**TO:****FROM:****DATE:****SUBJECT: Campaign # 03E-061**

Villa International has informed Newmar of an anchorage bolt for the Driver/ Passenger seat that could fail in the unlikely event of an accident, potentially leading to serious injury or death to the occupant.

SUBJECT: Newmar Serial #, Chassis Serial #, and Campaign #03E-061

* BELT BUCKLE *

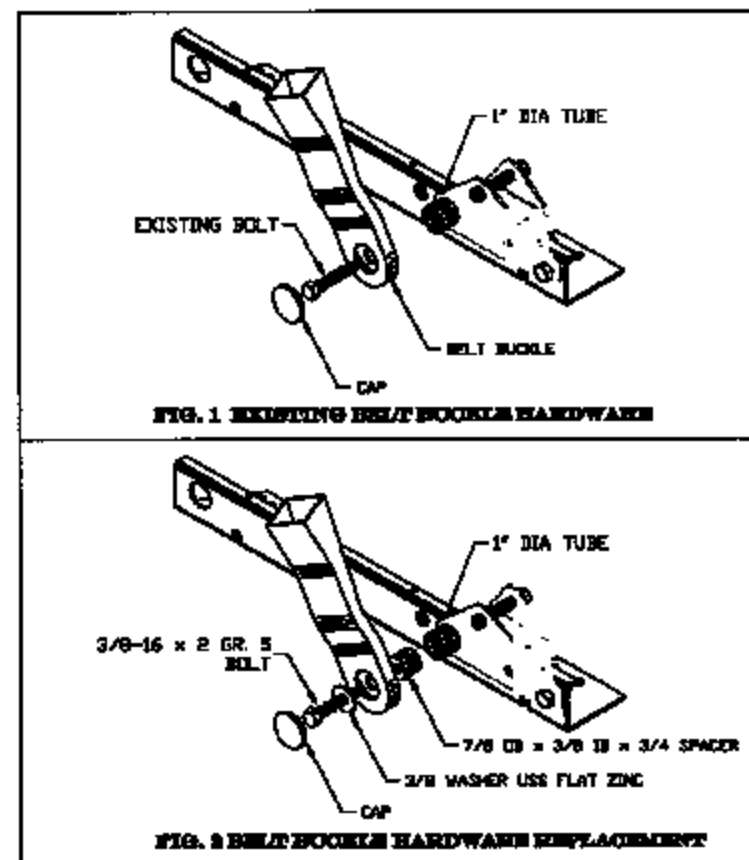
The seat belt latch where bolted on the seat frame may fail in the unlikely event of an accident.

Due to a hollow space in the location of the buckle attachment, the bolt may not be supported and may shear.

A bushing will be installed along with the grade 5 bolt.

- STEP 1. Locate and remove bolt from aisle side seat belt buckle.
- STEP 2. Insert 7/8 OD x 3/8 ID x 3/4 spacer into 1" diameter tube.
- STEP 3. Re-install belt buckle with 3/8 USS flat washer zinc & 3/8-16 x 2, grade 5 hex bolt.
- STEP 4. Tighten bolt to 30 ft. lbs.

1. LOCATE BELT BUCKLE, I.E., AISLE SIDE OF THE VEHICLE. SEE ABOVE FIGURES. BELT BUCKLE LOCATION INDICATED BY AN ASTERISK (*).
2. TAKE OUT THE CAP AND LOOSEN EXISTING BOLT TO REMOVE BELT BUCKLE. SEE FIG. 1.
3. INSERT 7/8 ID x 3/8 ID x 3/4 SPACER INTO 1" DIA. TUBE. SEE FIG. 2.
4. RE-INSTALL BELT BUCKLE WITH 3/8 USS FLAT WASHER ZINC & 3/8-16 x 2 GRADE 5 HEX BOLT. SEE FIG. 2.
5. TIGHTEN BOLT TO 30 FT. LBS. PUT CAP BACK ON.
